Invitation to Tender (ITT)
Main Entrance/Colonnade Glazing/Roof Replacement
Reference #: NGC110697
Buy and Sell Reference #: PW-17-00789081
September 15, 2017

ADDENDA # 3

1/14

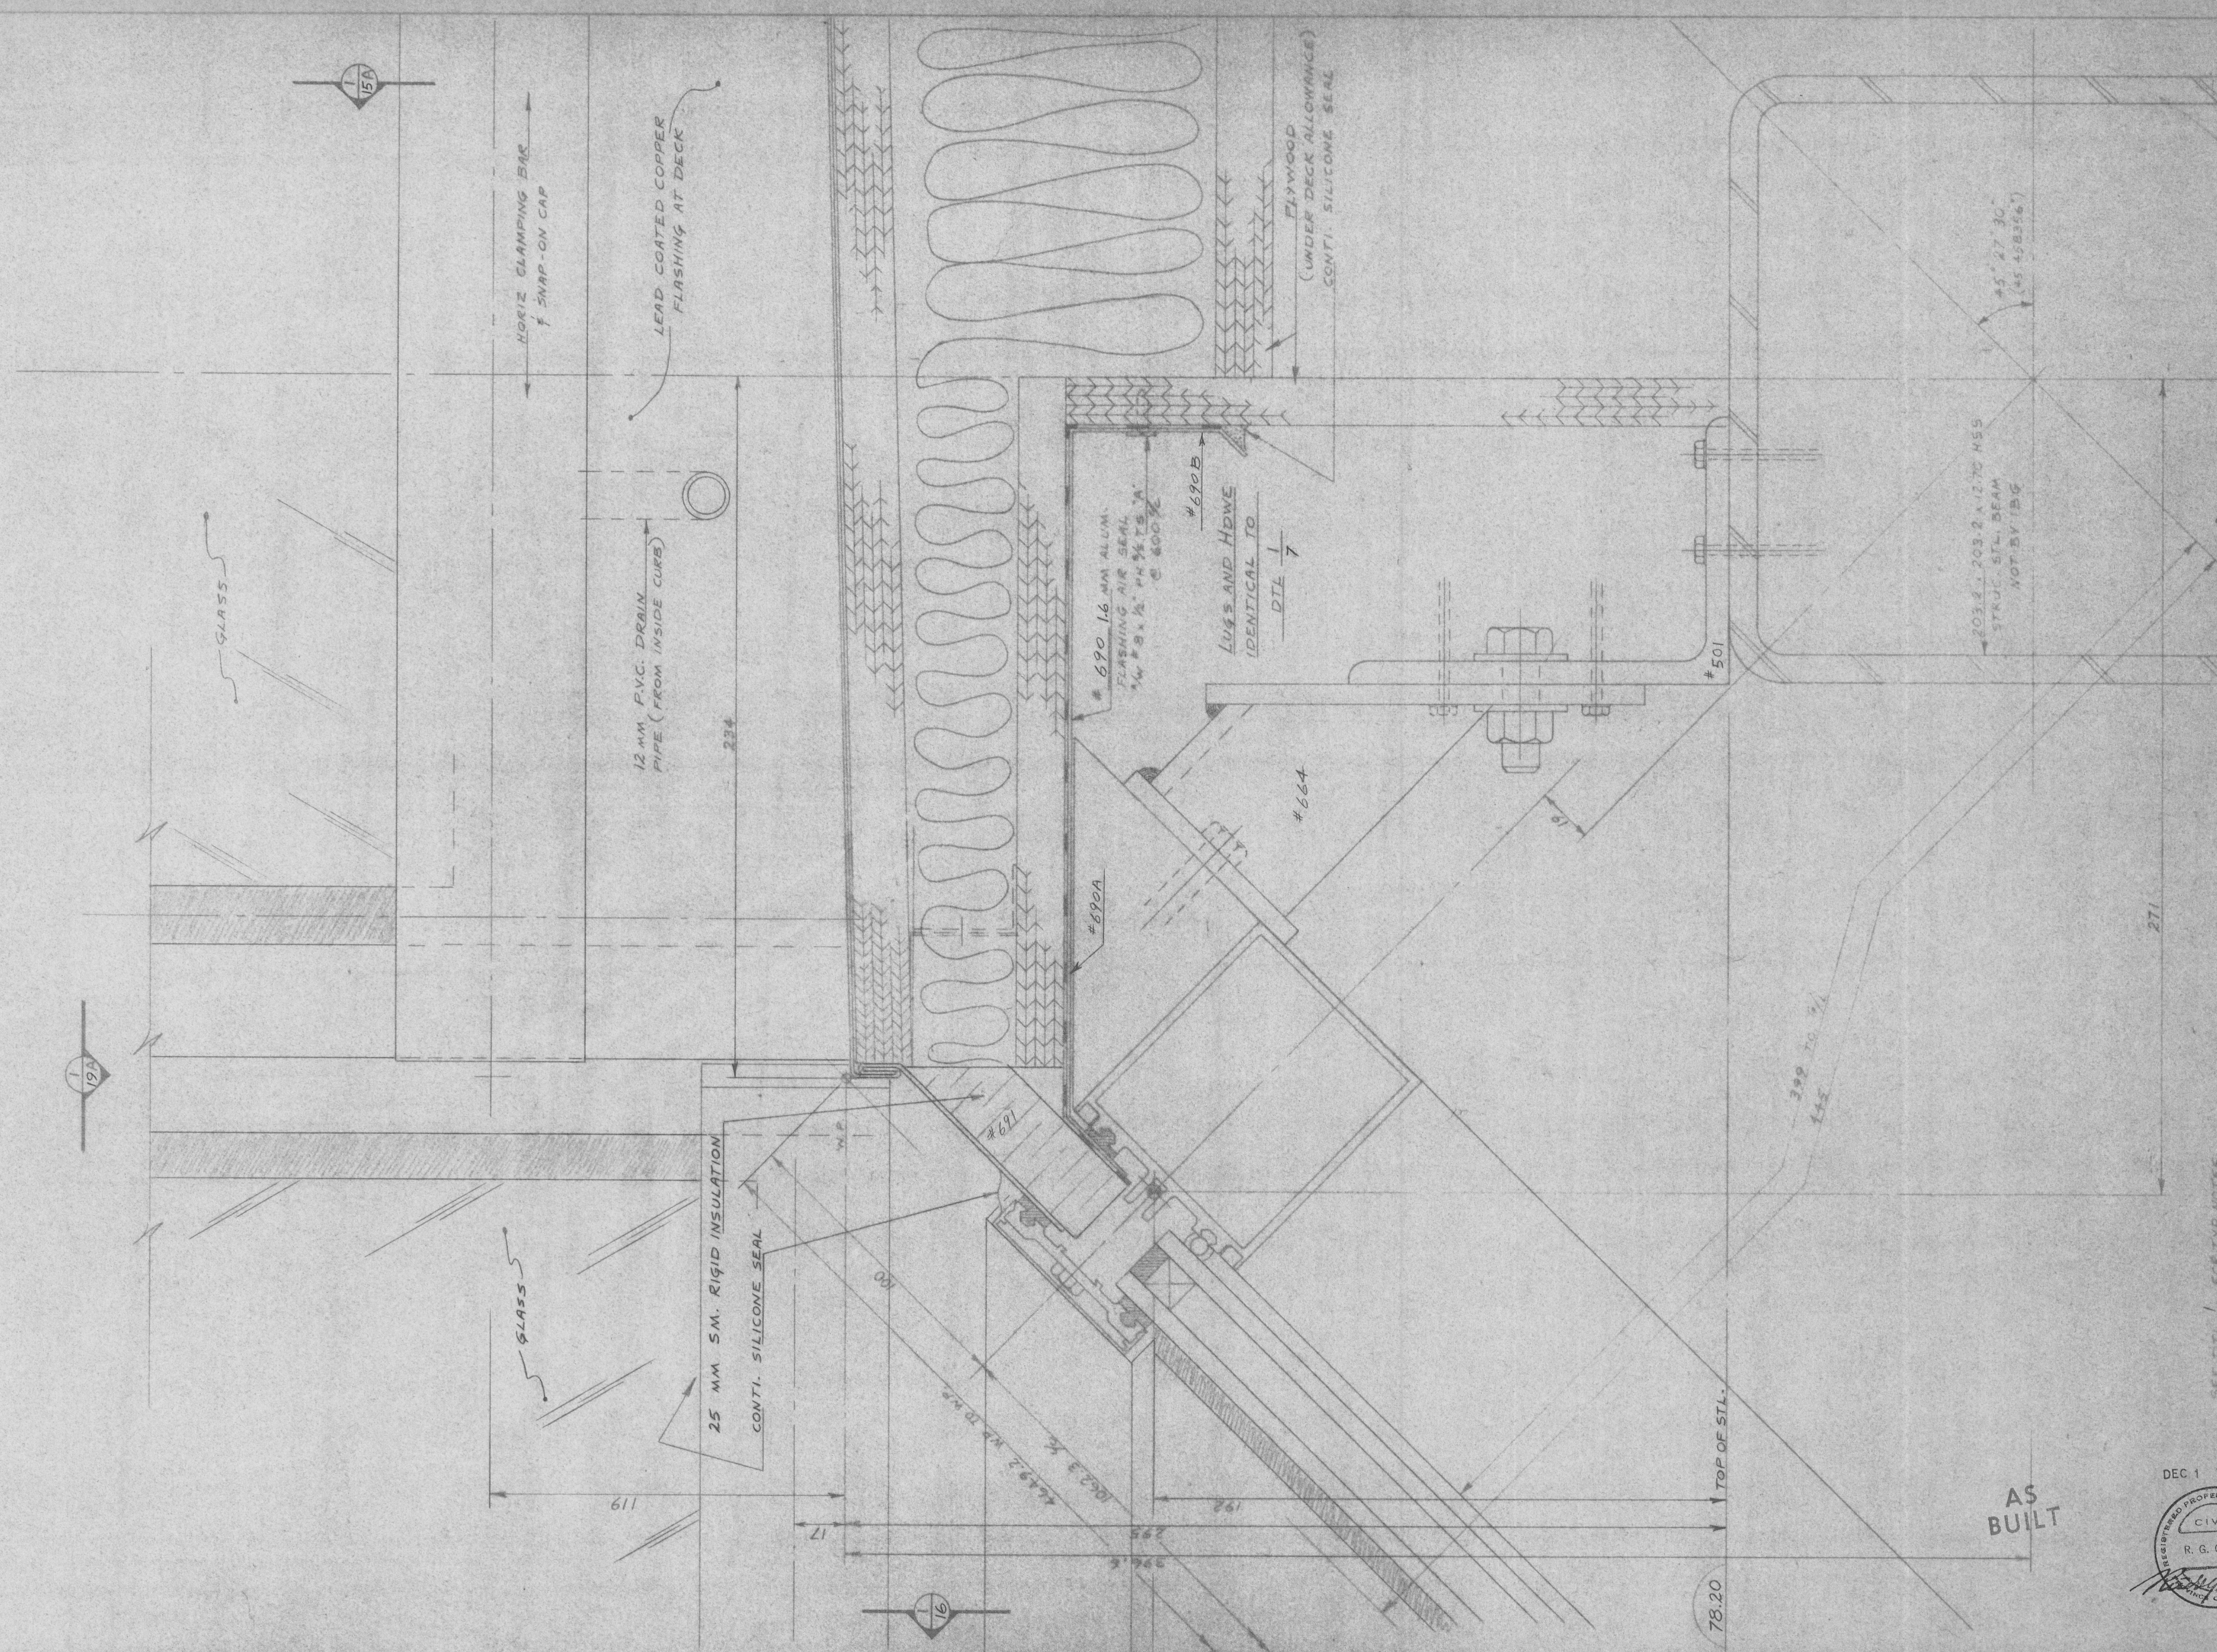
8. Please provide detailed, highlighted sketches and narratives of the extent of demolition to the roofs. Please ensure this details the full original structure of the roof build up.
 - a. As per specification Section 07 65 00, the roof demolition is to include the removal of all components from the exposed, lead-coated copper to the top of an original vapour barrier. The attached excerpts from the original shop drawings illustrate the components described in the specification which should be anticipated for removal as part of the required roof demolition (reference details 1/14, 1/15 and 1/23, attached).
